Service Bulletin #283

SB-283
011807
ECR 9119

Minimum height for RAM 1500 kit

fig. 1

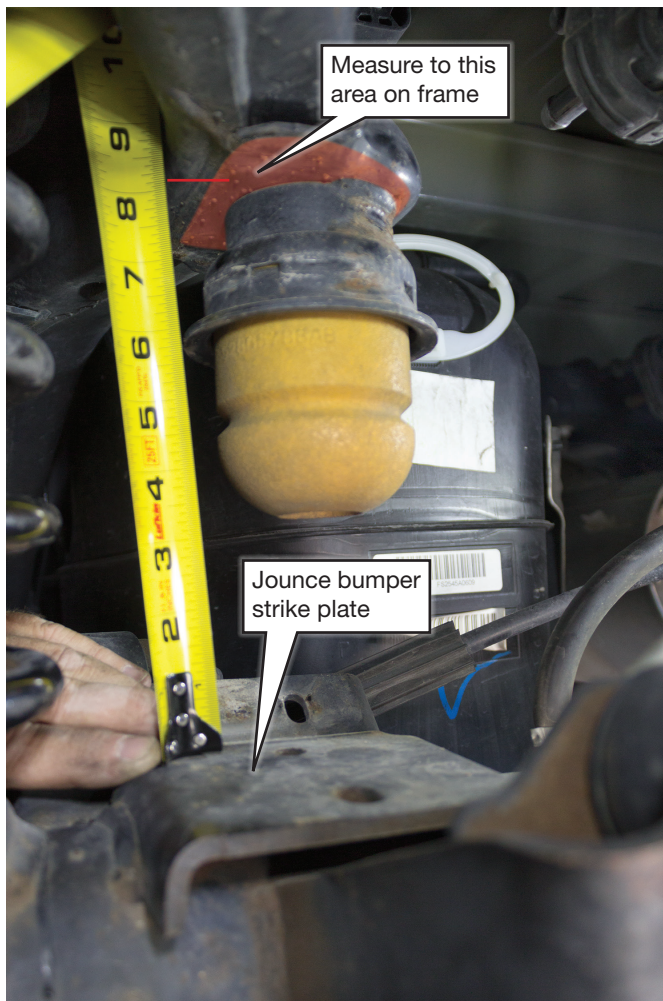
For kits 57370, 88370 and 89370, there must be 8 1/8" between the jounce bumper strike plate and the vehicle frame. Alternatively, measure at least 23 1/2" from the center of the axle to the lip of the fender. If these measurements are less than required or the vehicle has plastic wheel arch moldings or has a modified suspension, contact Air Lift customer service for assistance.
